EGG-EA-6616

ADEQUACY OF STATION ELECTRIC DISTRIBUTION SYSTEM
VOLTAGES, FORT CALHOUN STATION

ADEQUACY OF STATION ELECTRIC DISTRIBUTION SYSTEM VOLTAGES
FORT CALHOUN STATION

Responsible NRC Individual and Division
J. Emami/Division of Systems Integration
J. Donohew/Division of Licensing
Docket No. 50-285
TAC No. 12738

Figure 1. Fort Calhoun unit single-line diagram.

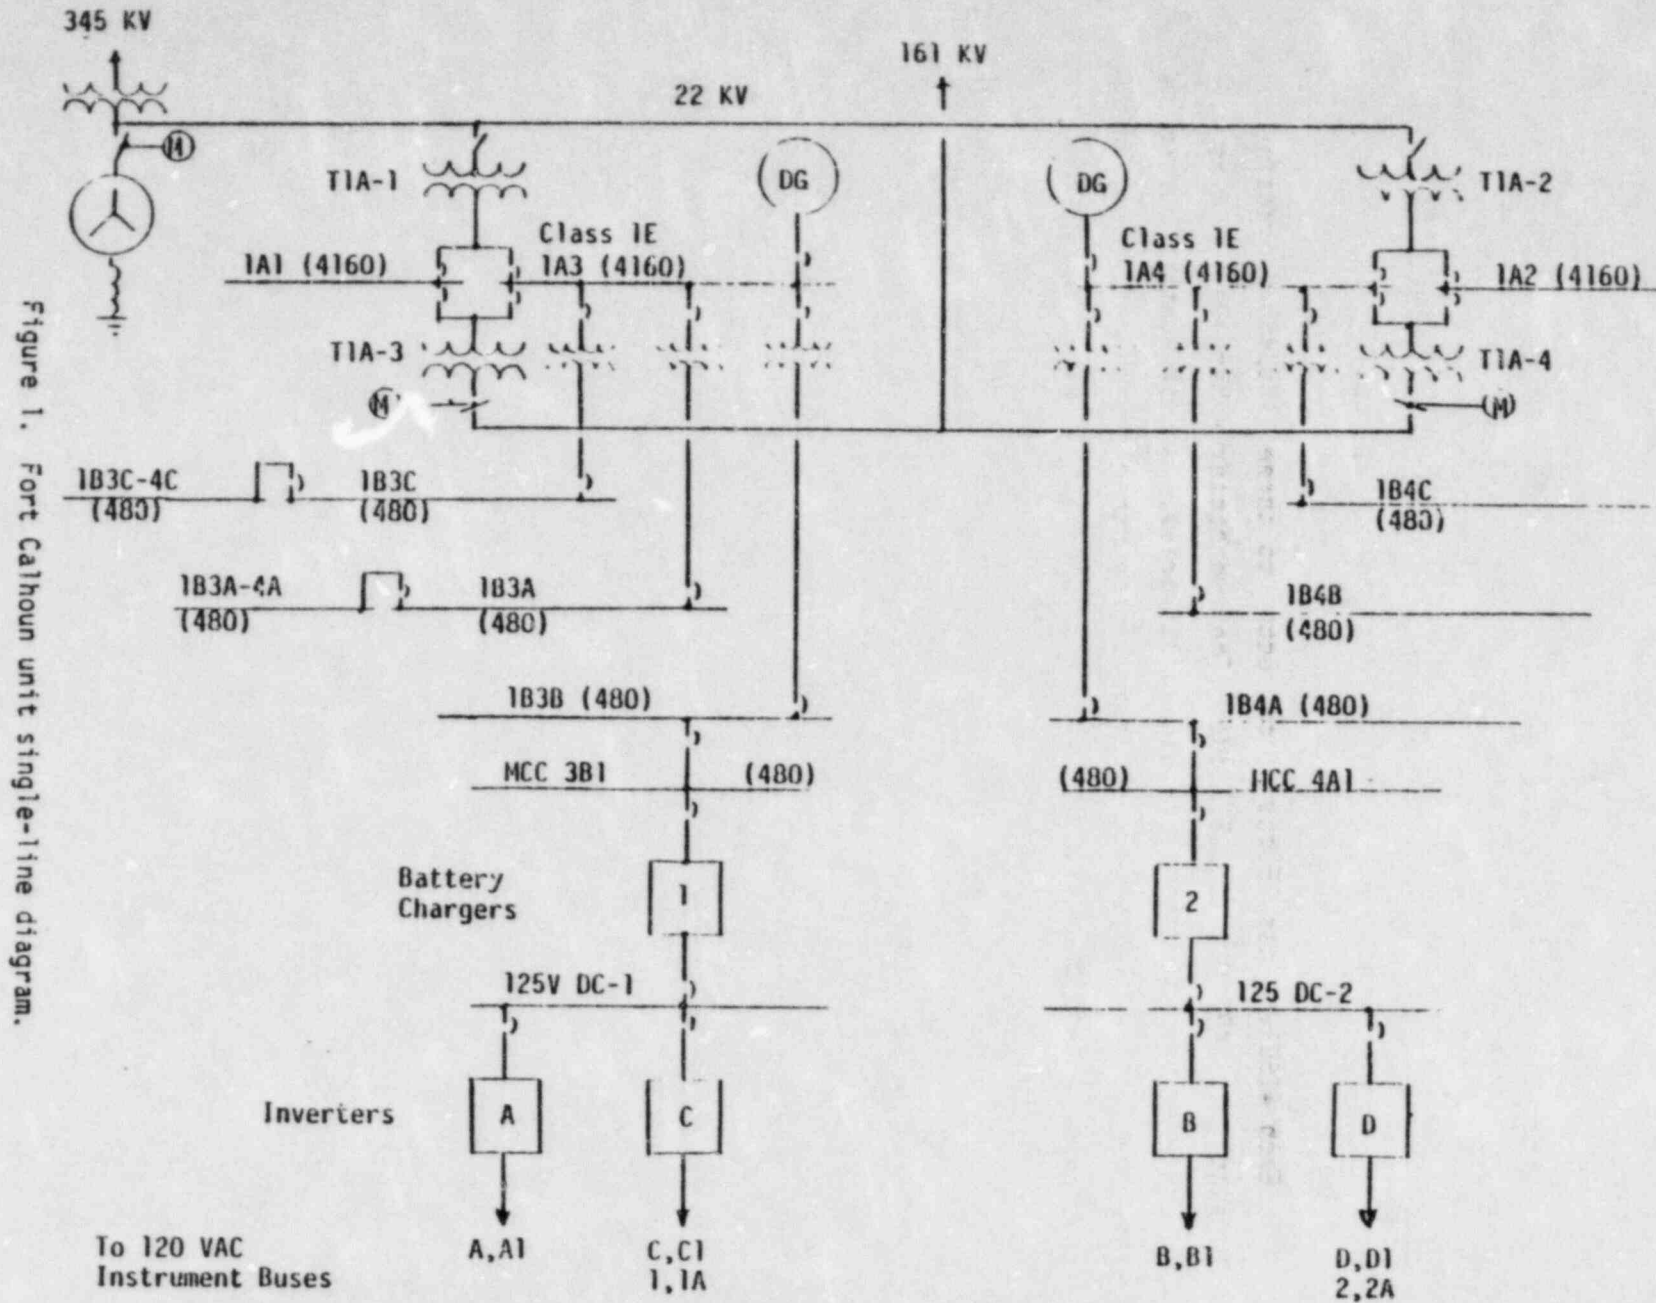
Figure 1 of this report is a simplified sketch of the Fort Calhoun electrical single-line diagram. Generator Auxiliary Transformers T1A-1 and T1A-2 are normally fed from the main generator. With the main generator disconnected (by a motor-operated disconnect switch), these transformers can also be backfed by the main transformer from the 345 kV grid. Station Auxiliary Transformers T1A-3 and T1A-4 are connected to the 161 kV grid. Any two of these four transformers are rated as capable of

supplying the total unit auxiliary load. Automatic fast transfers are provided to switch the power source from the generator auxiliary transformers to the station auxiliary transformers.

Each 4160 V Class 1E bus is connected to three 4160/480 V transformers to supply the 480 V Class 1E loads. The two battery chargers shown on Figure 1 supply the unit dc buses and batteries. A third battery charger, not shown, is available should either of the other two be out of service. The two dc buses power four inverter fed 120 V ac instrument buses.
